Sparex Service Info

TD43813/4

Part Nr. S.43813/ S.43814

Perkins – A3.152 AD3.152

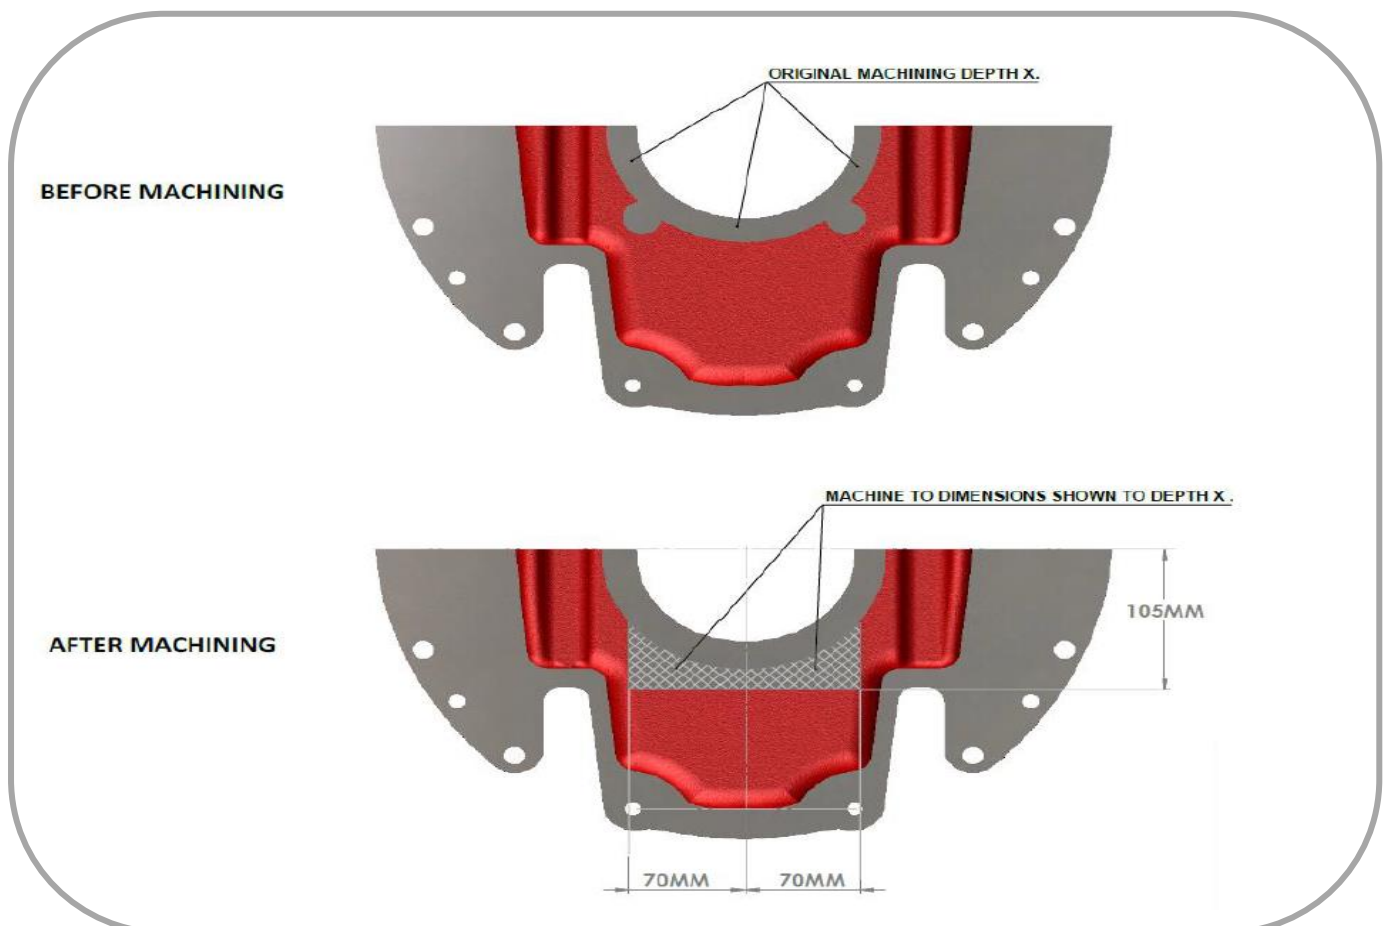
Info: Sump Modification required when replacing Perkins A3.152 and AD3 152 short motors fitted with rope type rear main oil seals fitted between 1959 and 1975.
